TECHNICAL SERVICE BULLETIN

Bulletin No.: TSB-042

Subject: Cylinder Collar Bolt Retention

Models: Quantum 40' Virtual Pipeline Trailers built before December 2020

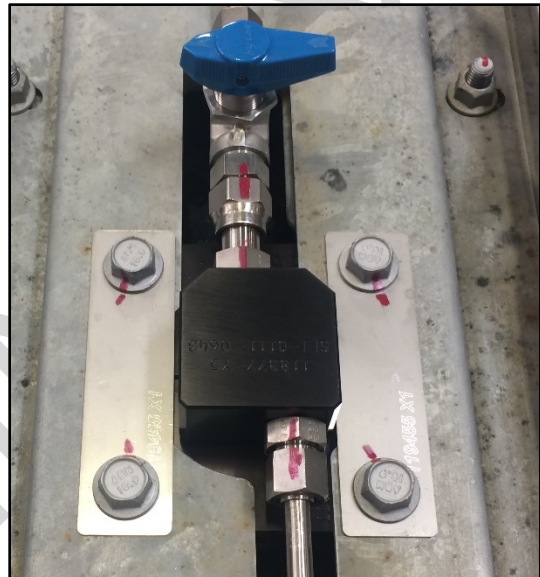
Some Quantum 40' VP trailers used in severe operating environments, have been found to have loose upper cylinder support collar bolts. When these bolts become loose it is possible for the fittings connected to the tank head to develop a leak. This issue appears to occur most frequently on the rear row of the trailer.

Quantum has developed a new fastening system that uses a safety wire to positively secure the fasteners in place.

Until the root cause of this condition can be positively identified, Quantum is recommending that this new fastening system be applied to the last two rows of the trailer immediately to prevent loosening or loss of these fasteners.
